WARRENTON PLANNING COMMISSION
Regular Meeting | January 12, 2023 | 6:00pm
Warrenton City Hall Commission Chambers | 225 S Main Avenue, Warrenton, OR 97146

- A. Continuation: L&D Race Tech Motorcycle Shop Site Design Review (SDR-22-2) on tax map 81022DD, Lots 06100, 06200, 06300, 06500, & 06501

TO: The Warrenton Planning Commission
FROM: Jay Blake, Planning Director
DATE: January 10, 2023
SUBJ: Site Design Review for L&D Race Tech, Inc. on Parcels in Section 22 of the City of Warrenton, Parcels #81022DD6100, 6200, 6300, 6500, and 6501

UTILITY PLAN
L & D RACE TECH SHOP
CIVIL IMPROVEMENTS
L & D RACE TECH, INC
WARRENTON, OR 97146

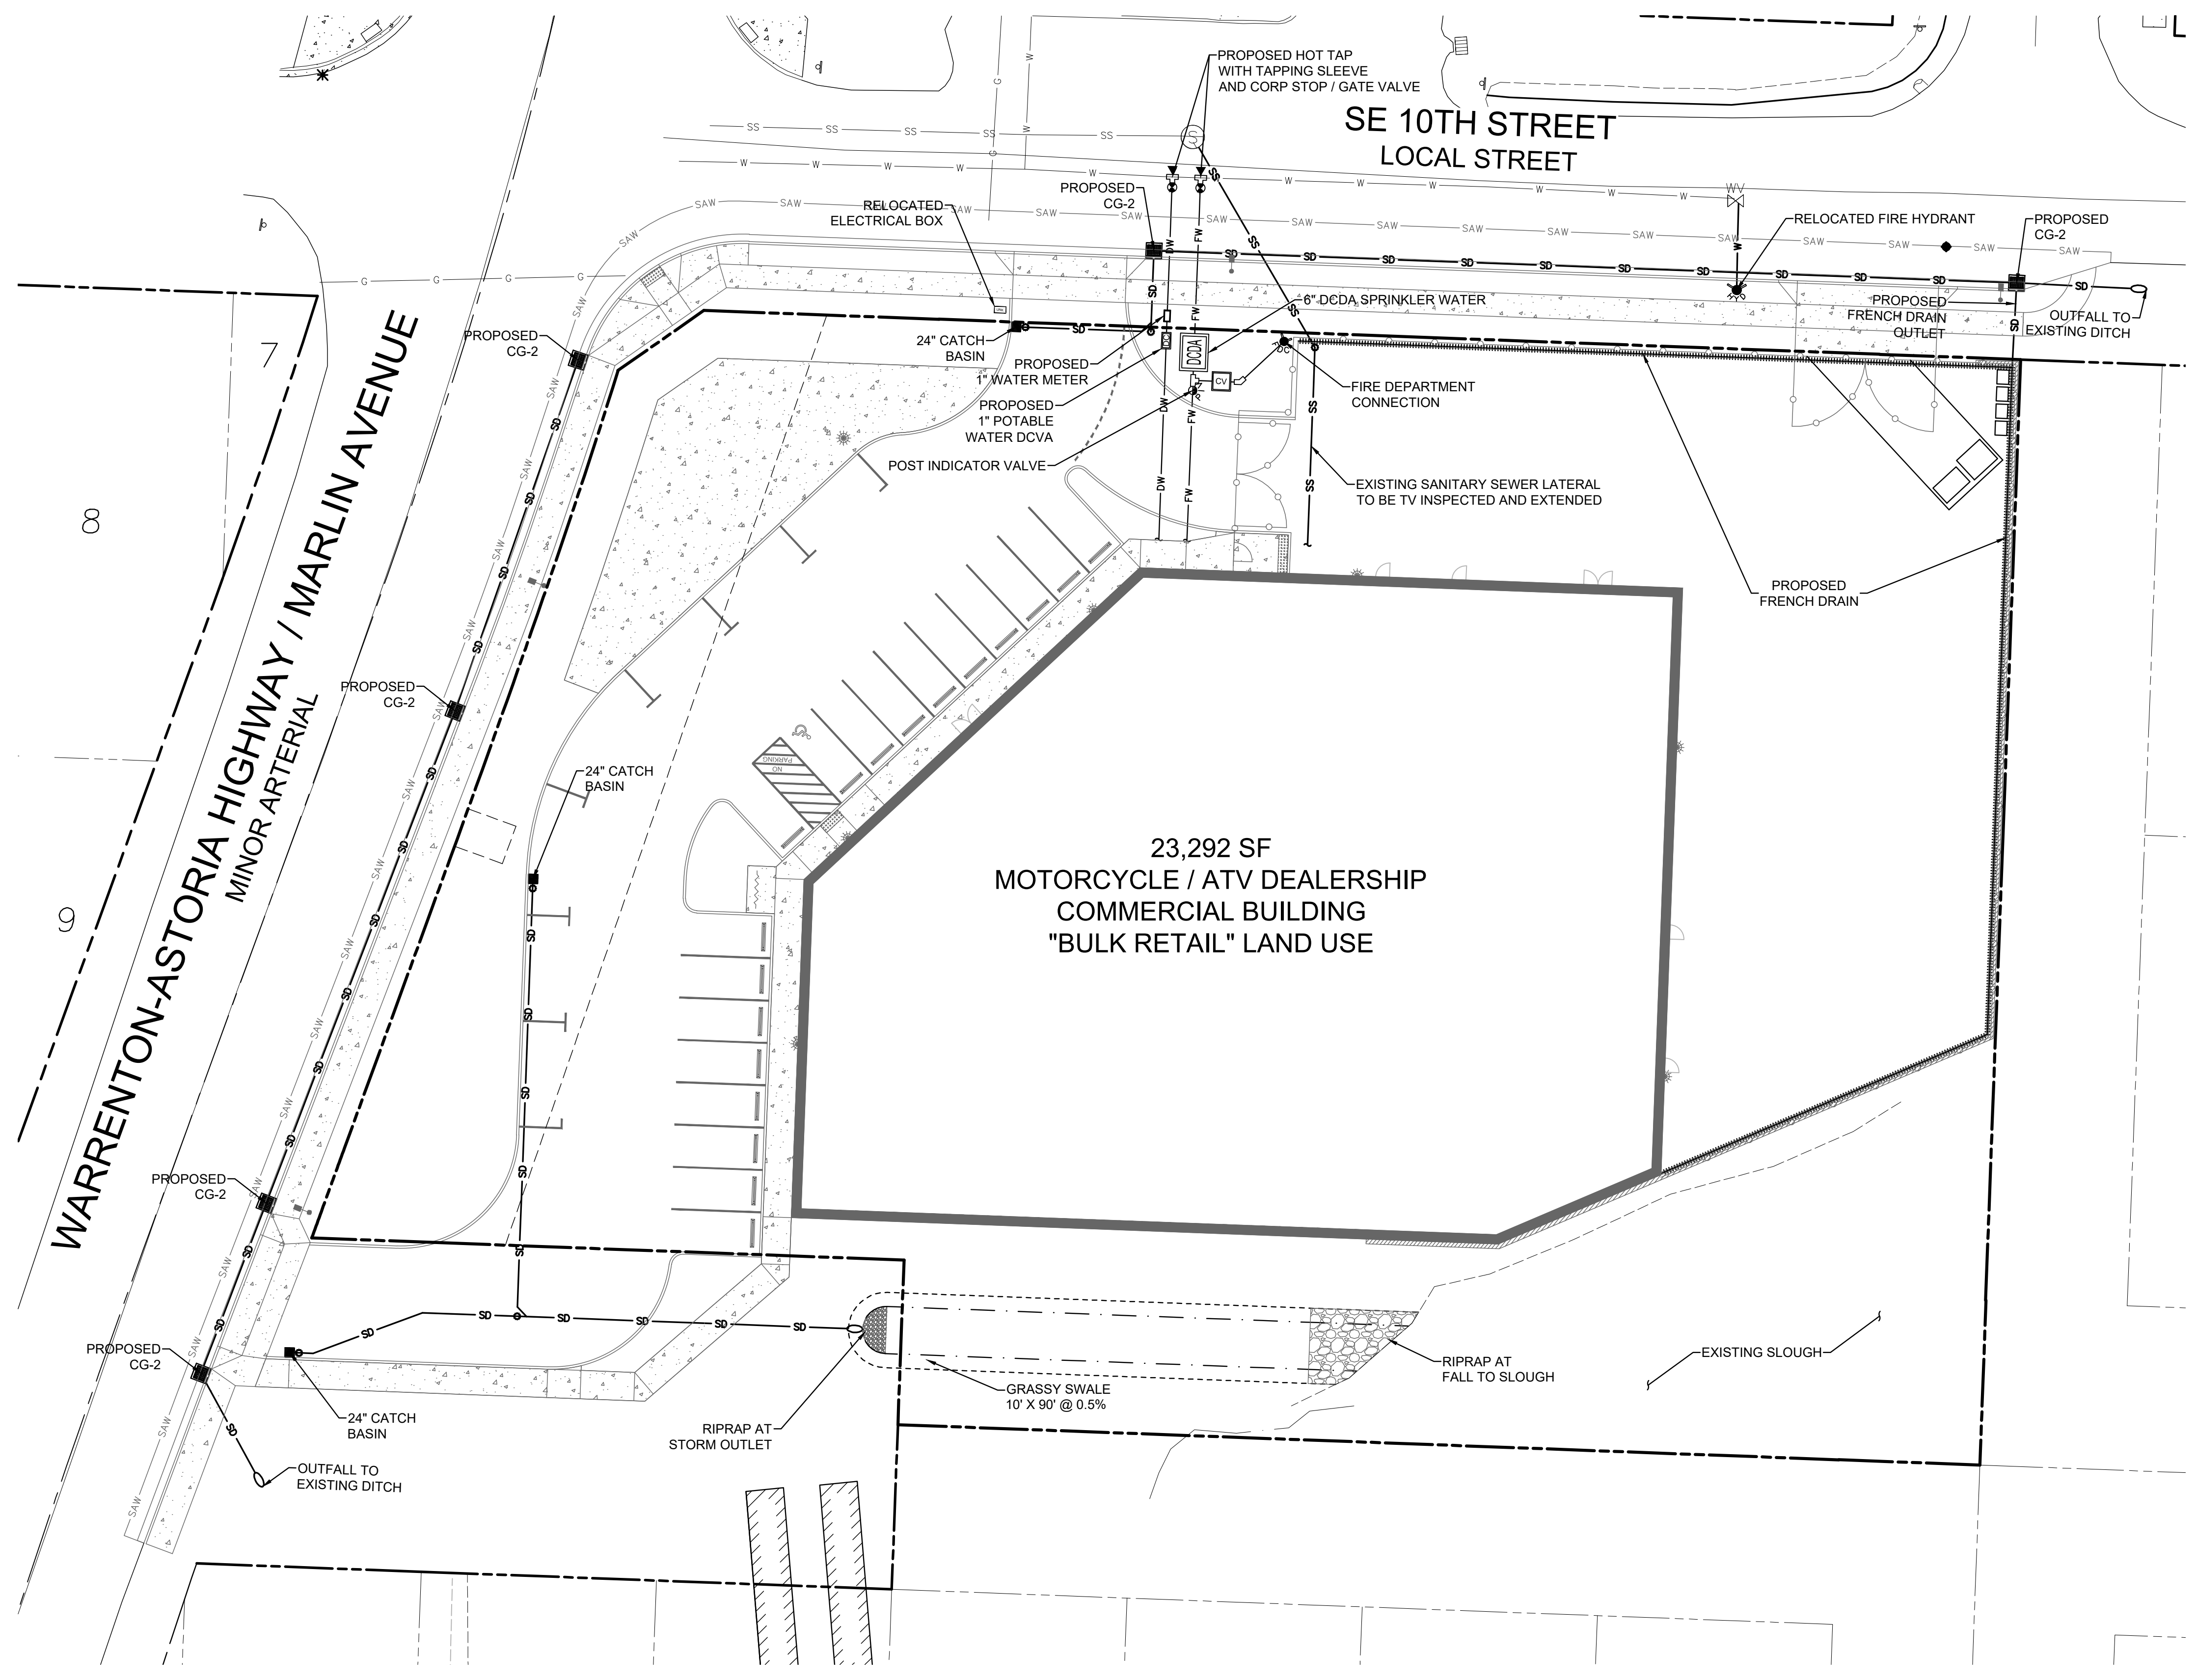
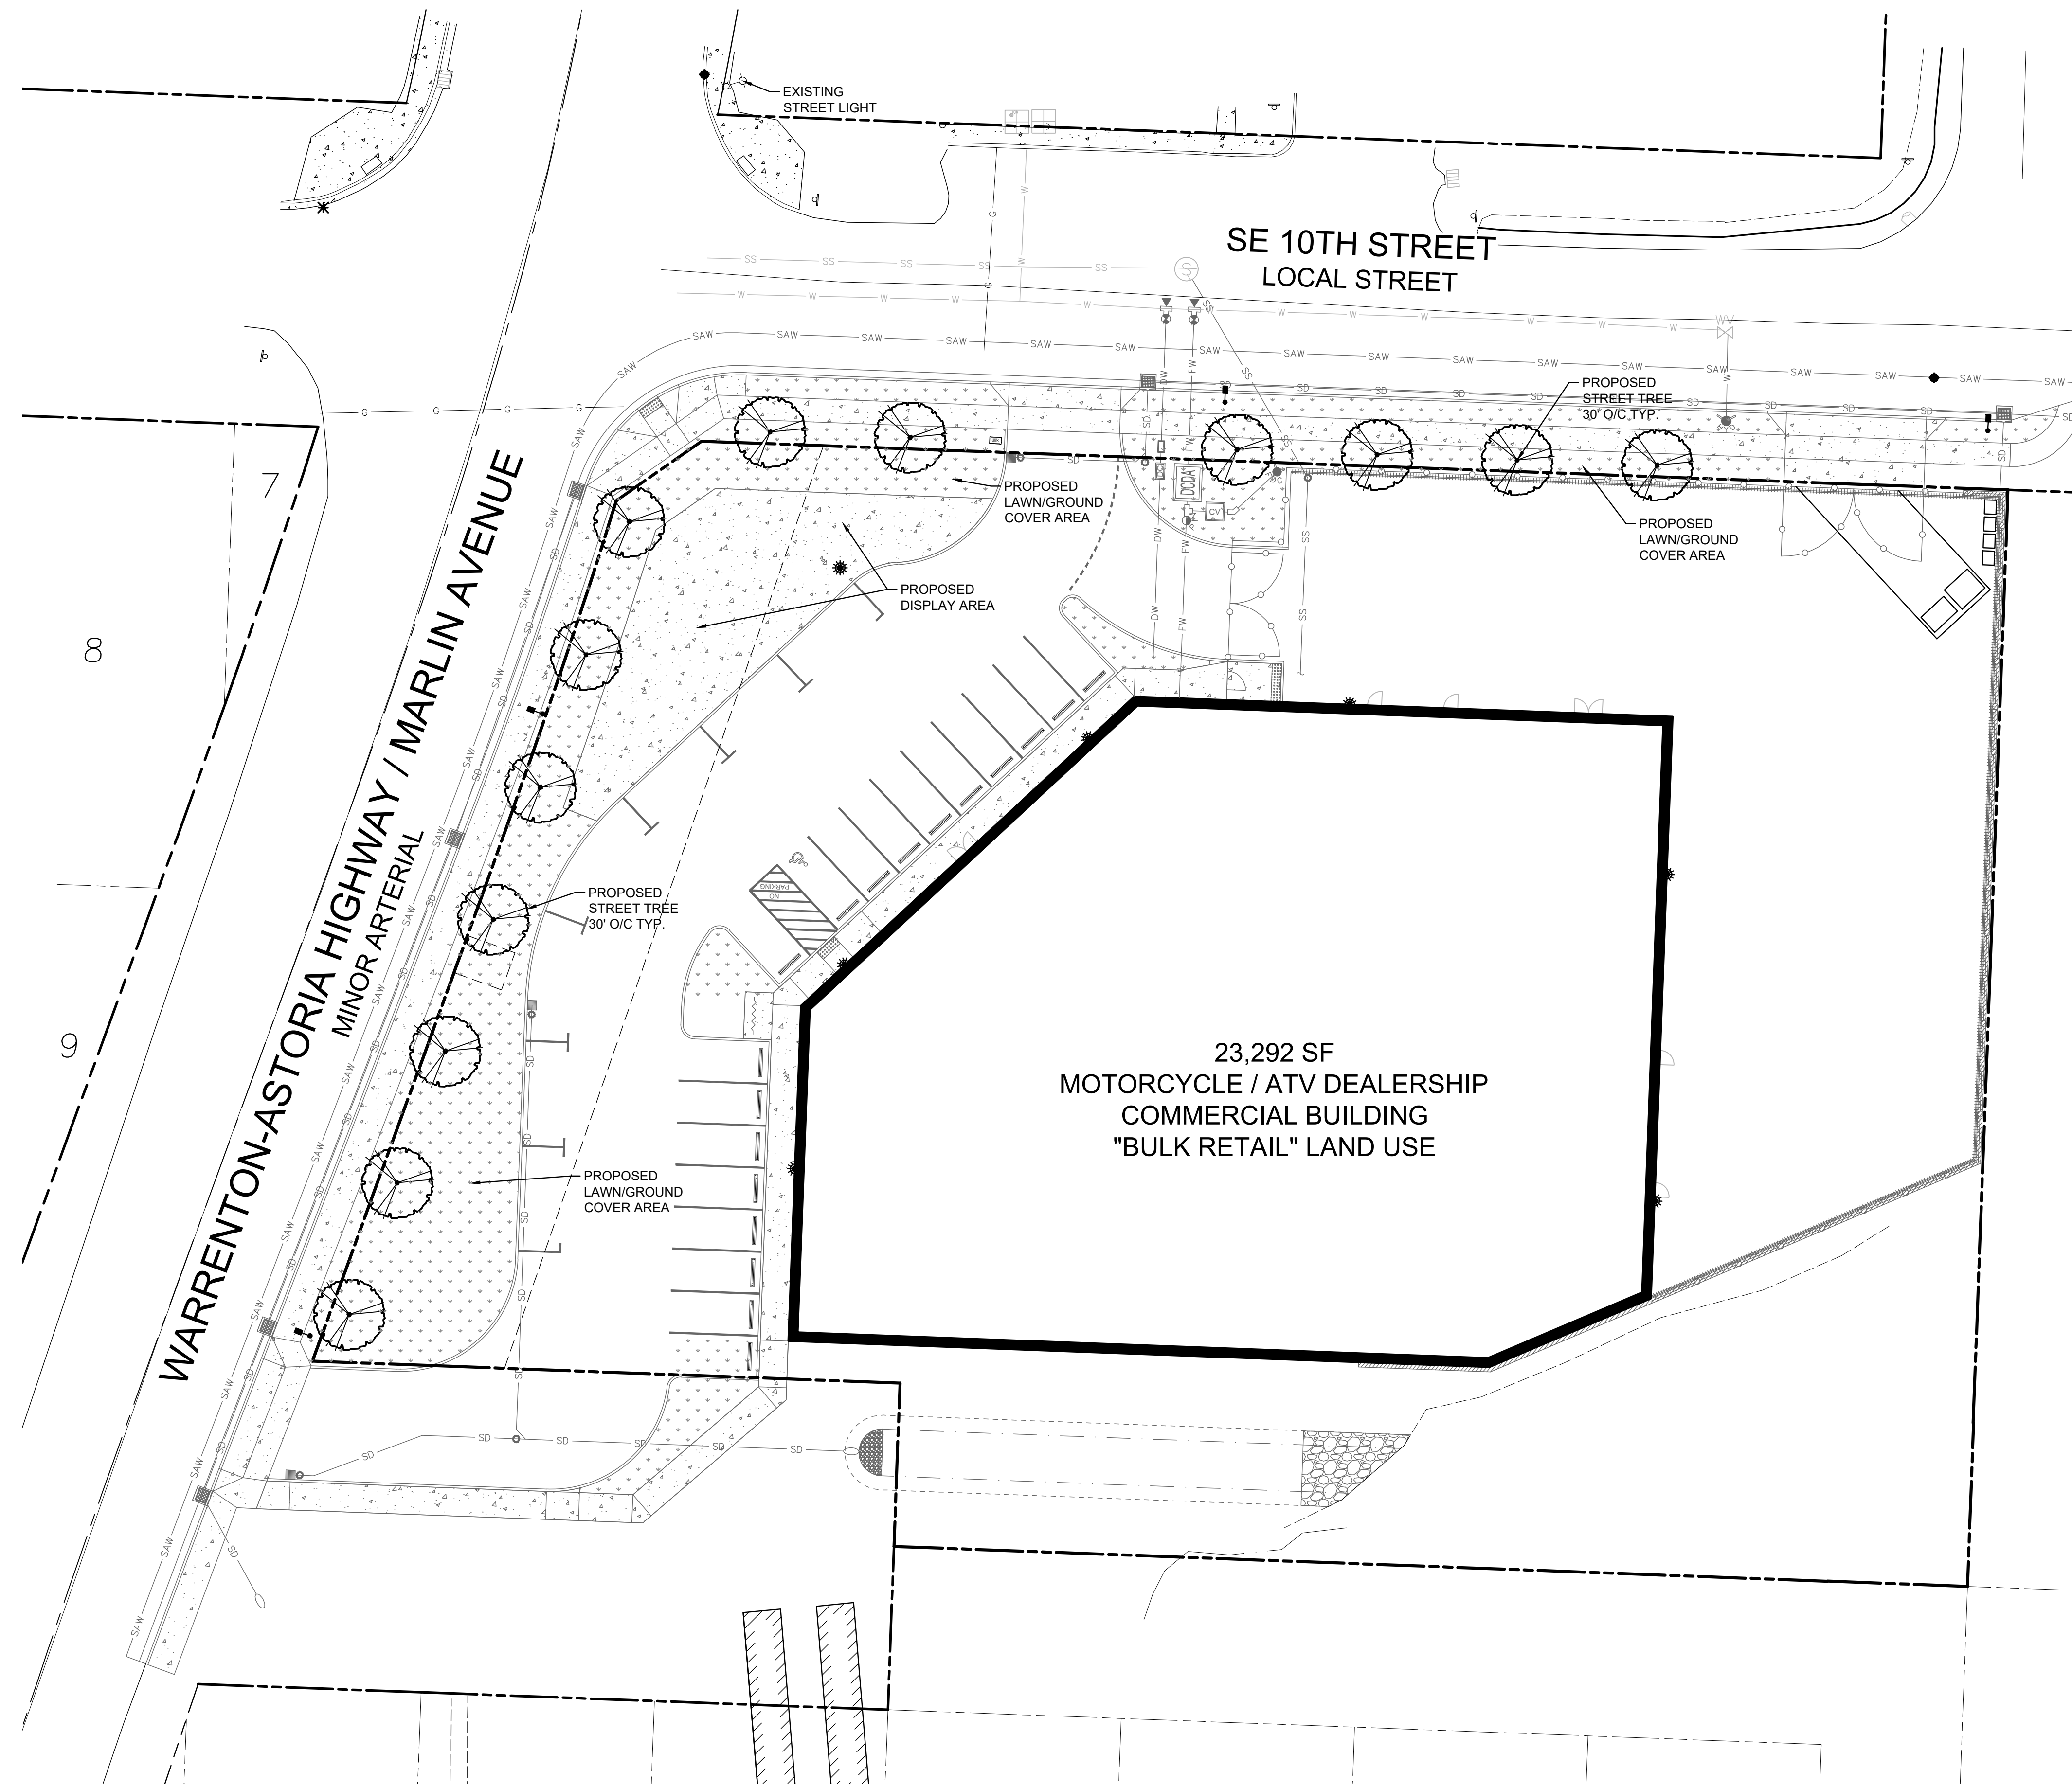
- 18 A preliminary stormwater report has been provided. The stormwater report does not and shall detail a downstream analysis, including the adjacent ROWs and flows from existing stormwater systems. In addition, the report shall analyze any loss in flood volume storage relative to fill proposed for this development. The stormwater management system shall be designed by a Registered Professional Engineer capable of meeting the requirements in the current version of the ODOT Hydraulics Manual.

- 19 Ensure on-site driveways, parking areas, aisles and turn-a-rounds to have on-site collection or infiltration of surface waters to eliminate sheet flow of such waters onto public rights-of-way and abutting property. The plans show sheet flow from the site into the adjacent right of way. Surface water facility plans shall be prepared by a qualified engineer and constructed in accordance with City standards.

- 20 Indicate how roof drainage will be conveyed offsite.
- 21 Site disturbance will require issuance of a State Construction Stormwater Discharge Permit, 1200-C, prior to any disturbance. 1200-C plans to be reviewed by the City prior to submittal to the State.
